ITEM 4. SECTION 96(2) APPLICATION: 116 BATHURST STREET SYDNEY**FILE NO: D/2012/1023/B****DEVELOPMENT APPLICATION NO: D/2012/1023/B****SUMMARY****Date of Submission:** 5 June 2014**Amended:** 24 October 2014**Applicant:** Mars City Pty Limited**Architect:** Candalepas Associates**Developer:** Mars City Pty Limited**Owner:** Osiglen Pty Limited and Minka Holdings Pty Limited**Cost of Works:** \$0**Proposal Summary:** The subject Section 96(2) application seeks to modify an approved Stage 1 building envelope in the following manner:

It is resolved that consent be granted to Section 96(2) Application No. D/2012/1023/B, subject to Condition 1 (Approved Development), Condition 22 (Conservation Management Plan and Adaptive Re-Use of Porter House) and Condition 23 (General Design Matters), being modified (with modifications shown in ***bold italics*** (additions) and ***bold italics strikethrough*** (deletions)), as follows:

Figure 9: Variations to the maximum height and roof profile of the Stage 1 building envelope to comply with the sun access plane

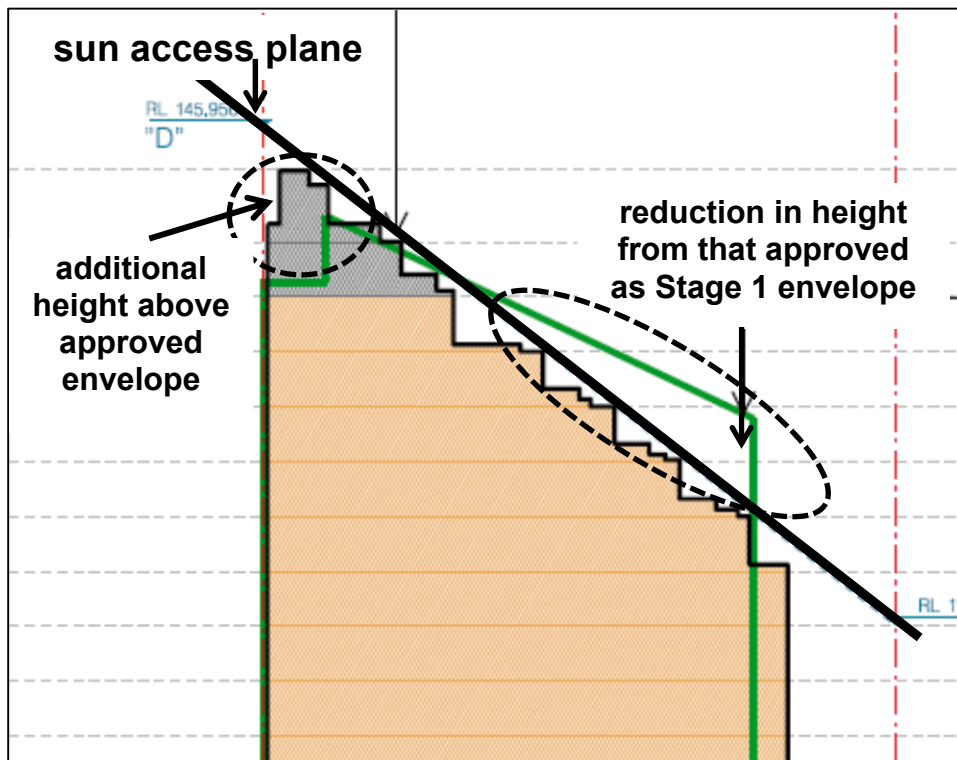
27. Consent is sought as part of the subject application to vary the height and roof plane of the building envelope in the following manner (refer to **Figure 9**, below):

- a reduction in height by up to 6 metres in the eastern portion of the site to delete the portions of the approved envelope that project above the sun access plane; and

- an increase in the overall height of the envelope at the far western portion of the site by 2.55 metres to a maximum height of 117.1 metres (RL 143.60).

Figure 10: Variation proposed to the front setback of the tower from Castlereagh Street

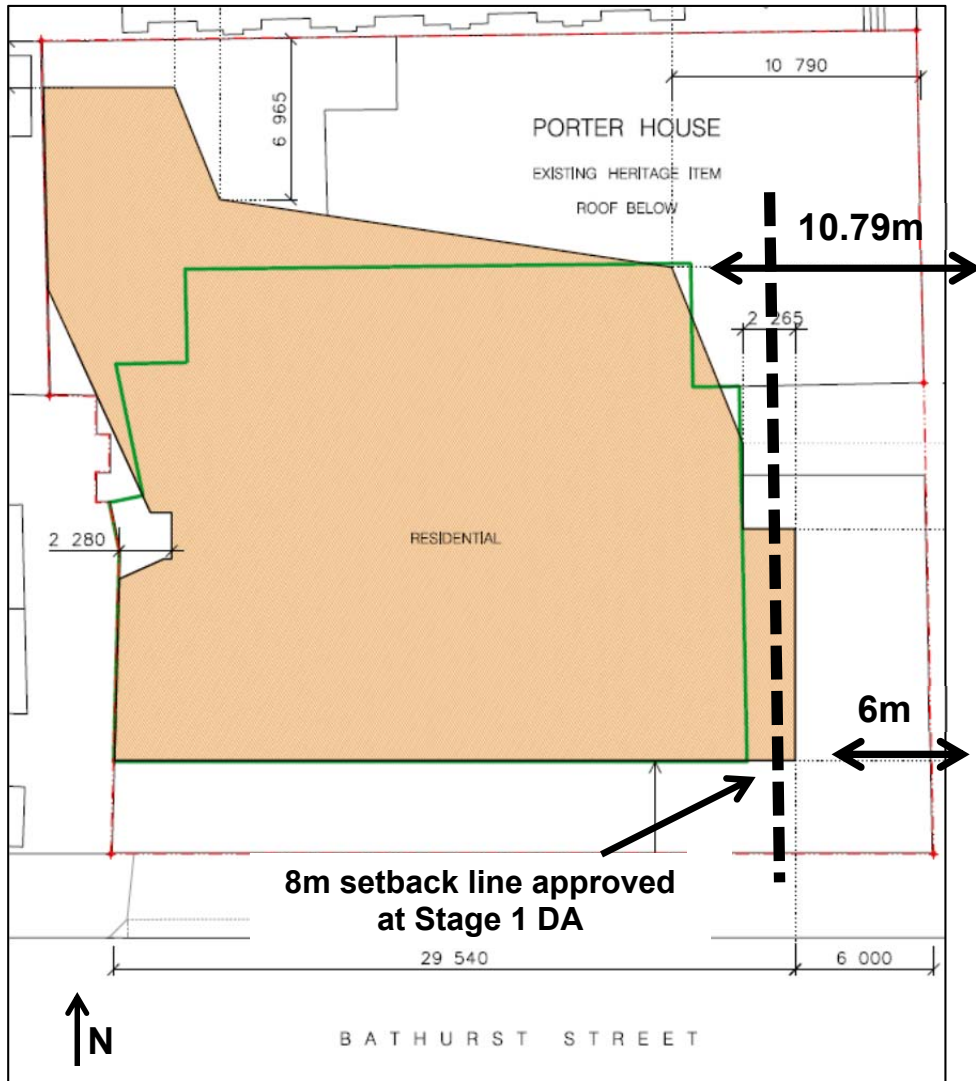
31. The Stage 1 Development Application approved a building envelope with a tower setback of 8 metres from the Castlereagh Street boundary of the site. The proposed modification seeks to modify the setback of the tower from Castlereagh Street to a variable setback of between 6 and 10.79 metres. **Figure 10**, below, illustrates the variation proposed to the setback of the tower from Castlereagh Street.

32. Whilst this represents a numeric departure from the 8 metre front setback control of Section 5.1.2.1, it is considered that the variation can be supported in this particular instance as the proposal still achieves the objectives for setbacks as outlined at Section 5.1.2 of Sydney Development Control Plan 2012 (SDCP 2012), in the following manner:

- (b) The proposed lift core is to be setback from the south facade of Porter House by a minimum of four metres.
- (c) The proposed tower is to be setback a minimum of **eight six** metres from Castlereagh Street.

Figure 11: View analysis of approved building envelope (with an 8 metre tower setback), looking south along Castlereagh Street

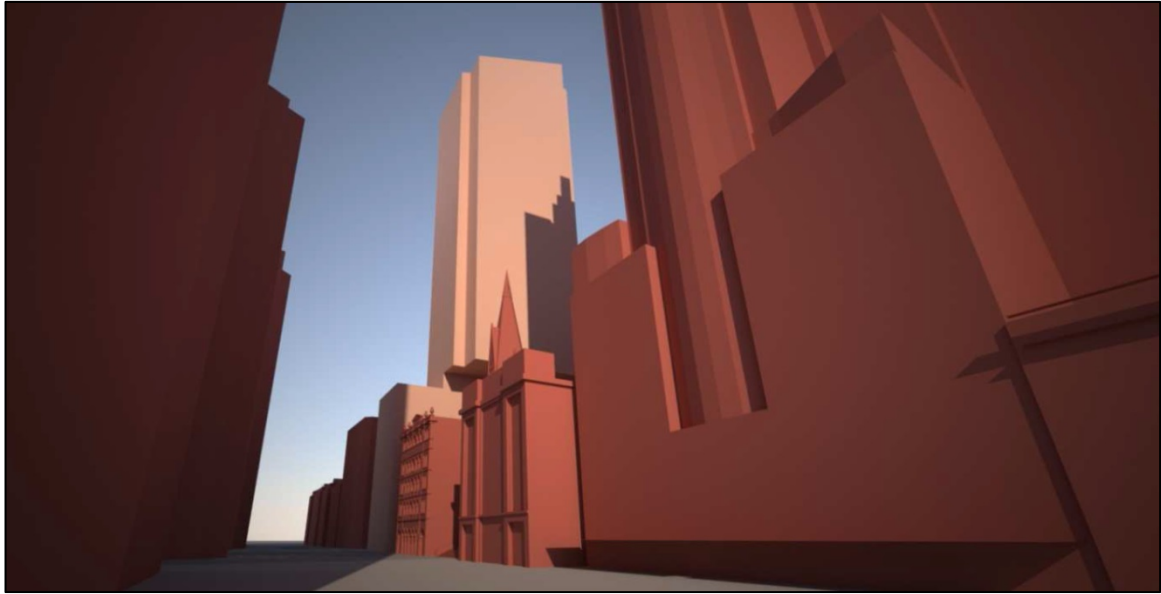
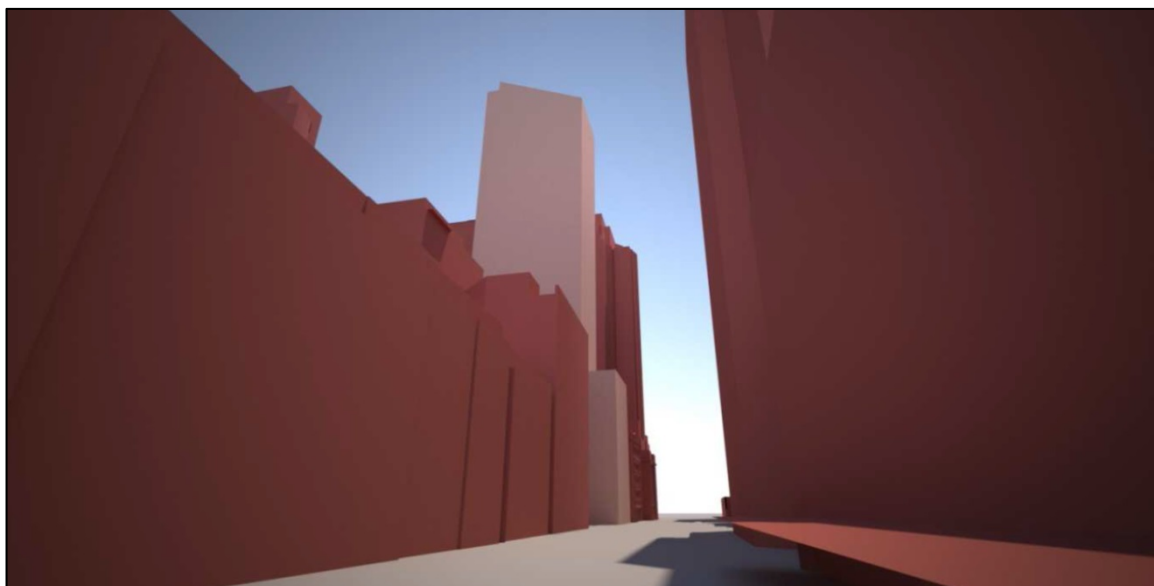
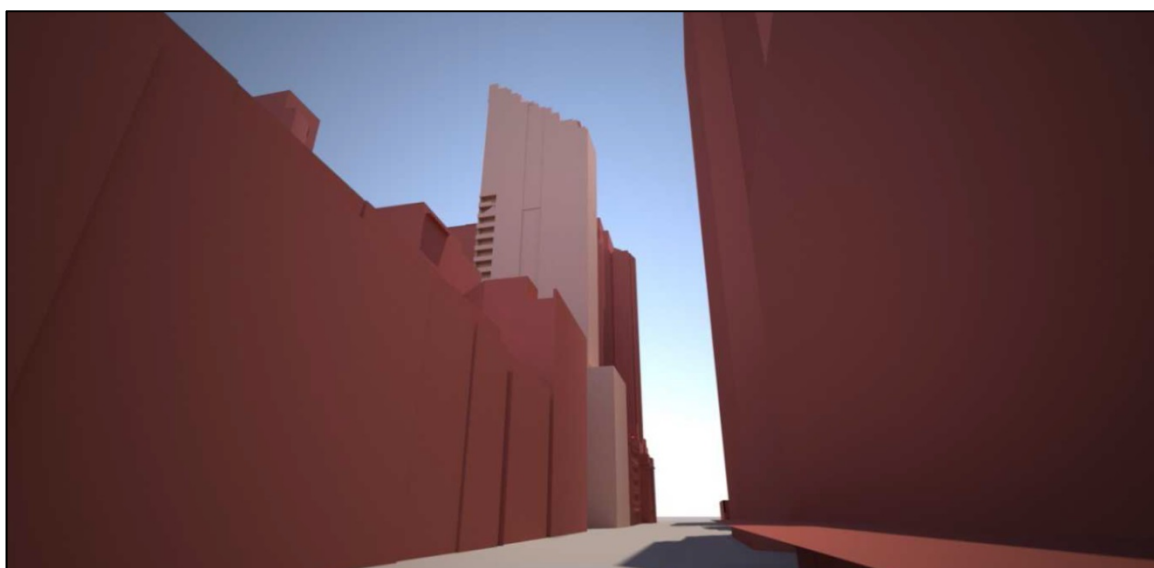
- (e) the proposal retains a podium that is of a height to reflect the predominant street wall height on both its frontages. **Figures 11 to 14**, below, provide modelling of the modification to the building envelope as viewed from street level (on Castlereagh Street). Review of this modelling illustrates that there is only a minor variation to the perceived bulk and scale of the building at pedestrian level resulting from the varied front setback. This would be further negated through articulation of the building envelope at the detailed design stage, as has been demonstrated in the concurrent Stage 2 development application;

Figure 15: The variations proposed to the Stage 1 building footprint on a typical podium level

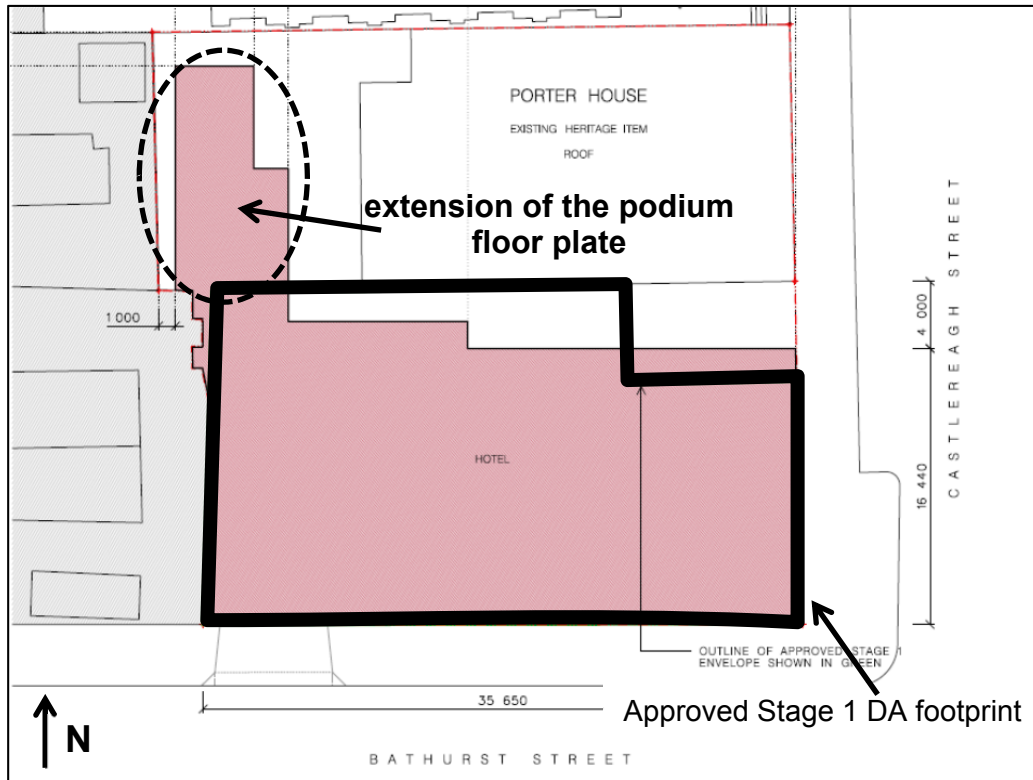
34. The subject application seeks to vary the approved building footprint of the podium and tower to expand the building footprint towards the northwest corner of the site (to the rear of Porter House). **Figures 15** and **16**, below, illustrate the modified footprint sought on typical levels of the podium and the tower, and highlights the variation sought from the existing approved Stage 1 DA building envelope.

Figure 17: Variation proposed to the recess between podium and Porter House

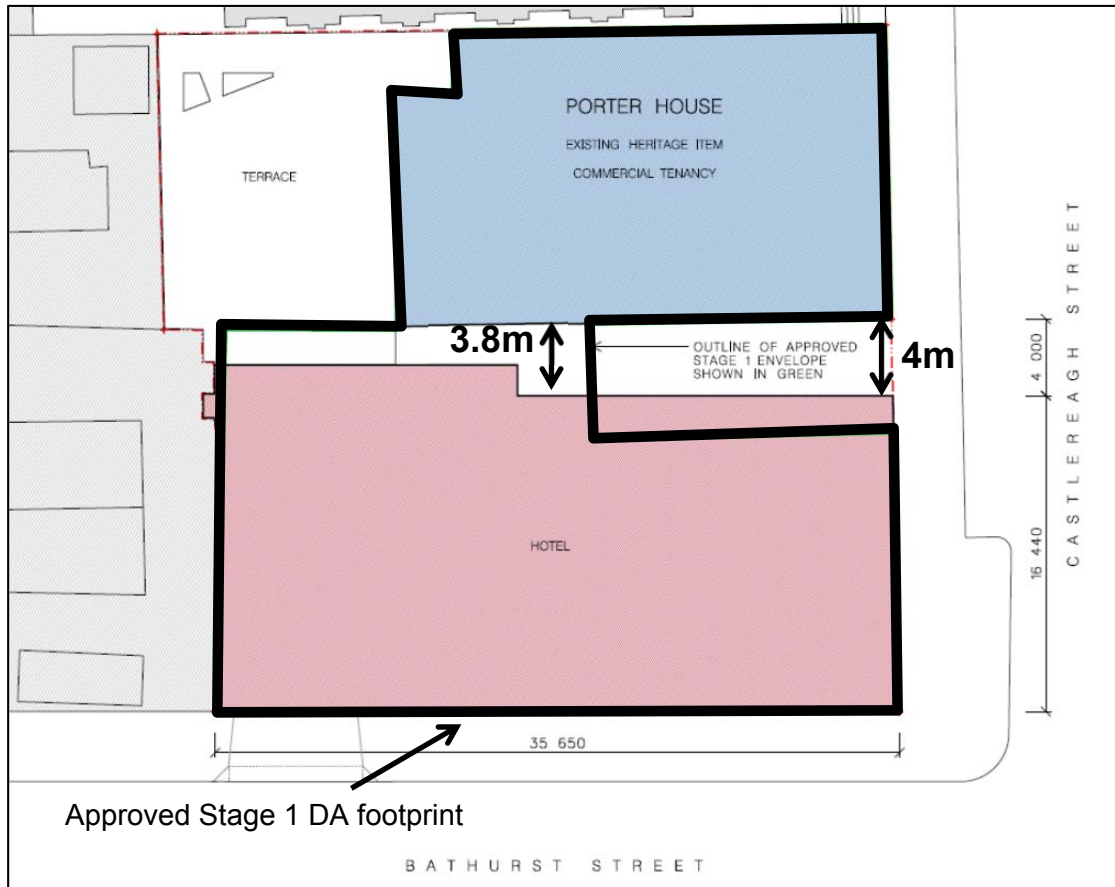
41. The assessment of the Stage 1 development application included the imposition of a detailed heritage design condition (being Condition 23 of D/2012/1023), which was intended to guide the preparation of schemes for the design competition and detailed design.
42. Condition 23(d)(ii) required a minimum separation or recess between the proposed podium of the new building and Porter House of 5.3 metres. The subject application seeks to reduce this separation to between 3.8 and 4 metres (refer to **Figure 17**, below).

43. Council's Heritage Specialist has reviewed the modifications sought to the envelope, as well as the detailed design of the scheme as part of the Stage 2 DA (refer to **Figure 18**, above). In this instance no objection has been raised to the extent of numeric variation sought to this condition as the design intent has been satisfied through an alternate design proposition of lengthening the recess between the buildings to give the distinction of space and separation.
44. As detailed in the recommendation section of this report, Condition 23(d)(ii) is recommended to be modified to reduce the minimum width of the recess to 3.8 metres to reflect the amended scheme.

- (ii) To be a minimum width of ~~5,300mm~~ **3,800mm**.
- (e) The proposed building at 110-118 Bathurst Street is to be structurally independent of Porter House, the building at 203 Castlereagh Street, Sydney.
